STAFF REPORT: 12/9/2020 MEETING

ADDRESS: 318 EDMUND PLACE

HISTORIC DISTRICT: BRUSH PARK

SCOPE: REVISION TO PREVIOUSLY-APPROVED APPLICATION/REPLACE WOOD SIDING WITH STEEL SIDING; REPLACE MATERIALITY AT STOREFRONT AND ROOFTOPP RAILING

A-2 building design. Purple arrows and outline indicate the location of the wood, vertical plank, charcoal stained siding.

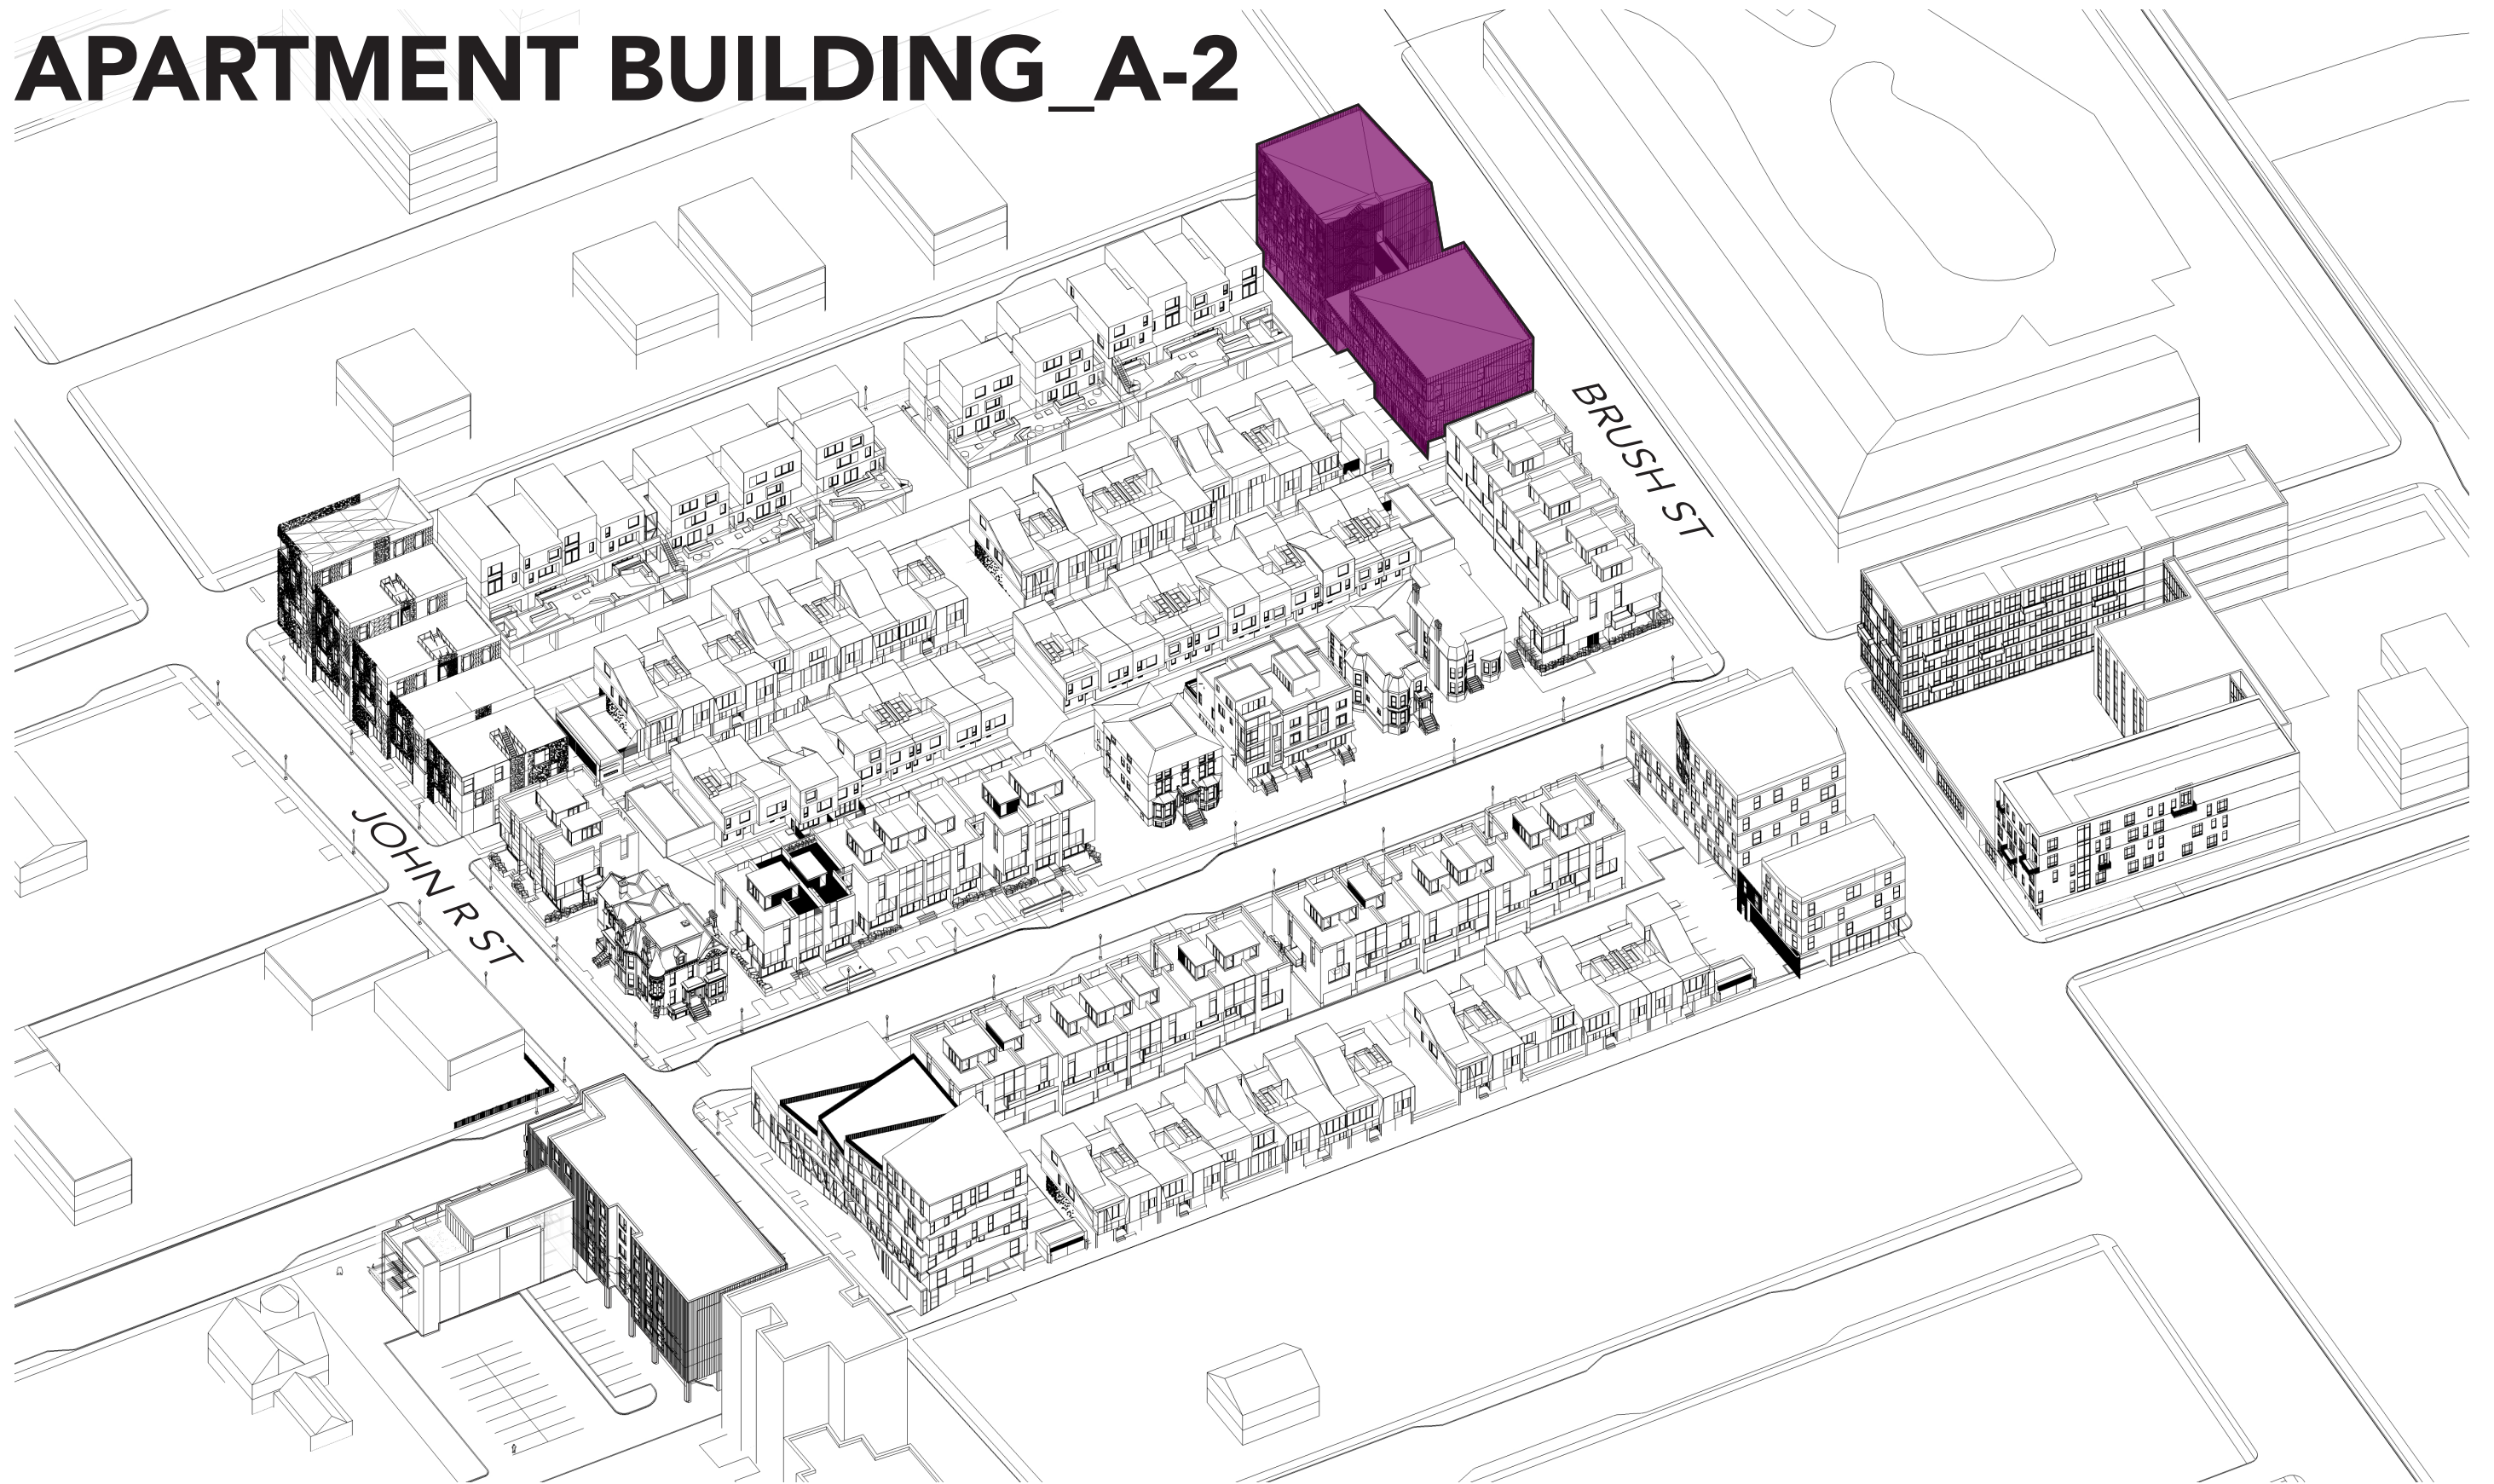
- Staff does note that the wood siding at the secondary material did provide a good textural and material variation to the ribbed red metal siding which will clad the building’s primary elevations and was more consistent with the district’s Elements of Design.
- The new siding proposed as a secondary cladding is ribbed and does provide a good contrast to the standing seam metal cladding which was approved for the building’s primary elevations in staff’s opinion
- It is staff’s opinion that the color of the new metal siding provides a good resemblance to the approved wood plan siding. The wood planks were approved this Body in 2016

was meant to be installed according to a vertical orientation. Staff would recommend that the new metal siding be vertically oriented, in keeping with the previously-approved wood siding

It is staff's opinion that the proposed project is appropriate to the defined Elements of Design for the Brush Park Historic District and the Secretary of the Interior's Standards for Rehabilitation (36 CFR Part 67). Staff therefore recommends that the Commission approve the issuance of a Certificate of Appropriateness for the project as proposed.

BRUSH PARK/CITY MODERN A2 SECONDARY CLADDING

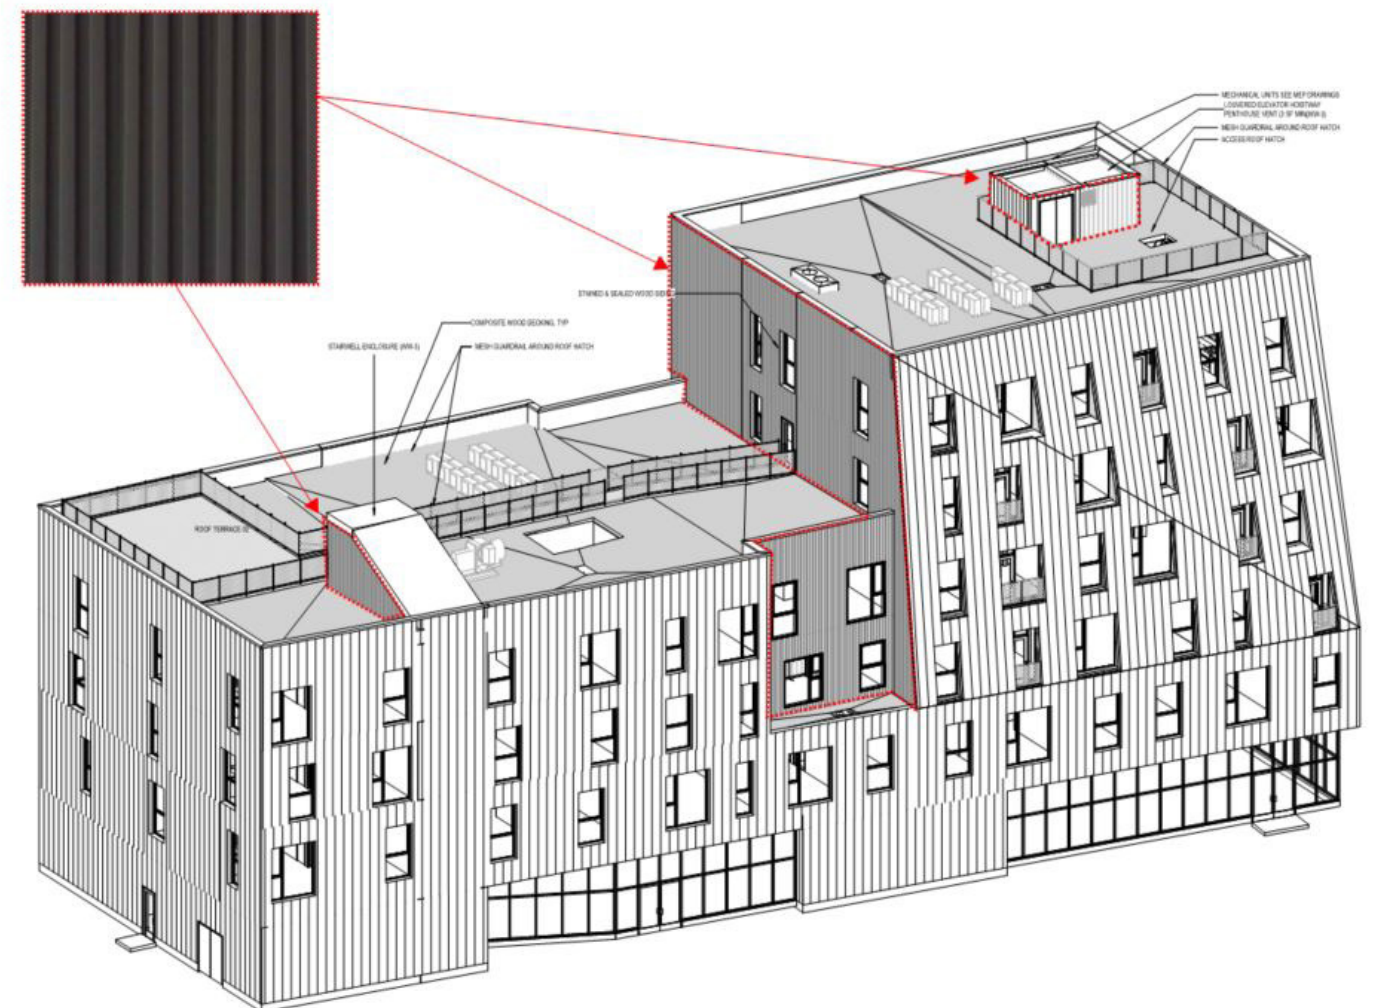
ORIGINAL: CHARCOAL GREY STAINED CEDAR PLANKS

PROPOSED ALTERNATE: MATTE BLACK METAL PANELS (ATAS METAFOR PROFILE)

WINDOW, DOOR, STOREFRONT

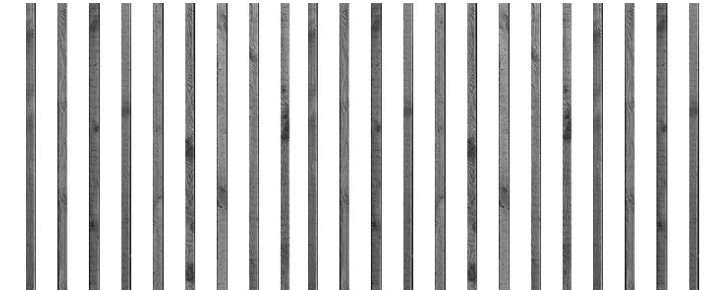
GREY STAINED CEDAR STOREFRONT MULLIONS + TYPICAL GLAZING

DARK ANODIZED STOREFRONT MULLIONS + TYPICAL GLAZING

RAILING, ACCENT, DETAILS

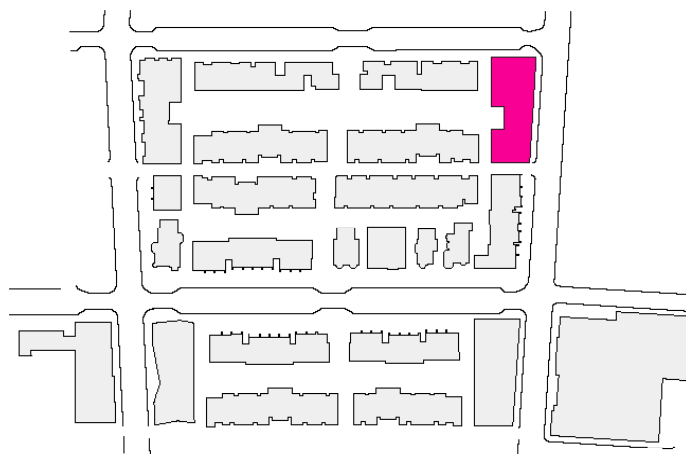
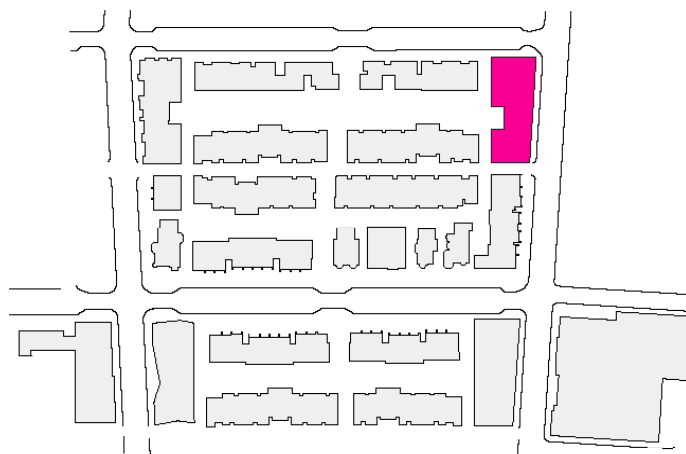
GREY STAINED CEDAR SCREEN

PAINTED BLACK METAL (SAME AS BUILDING A4)
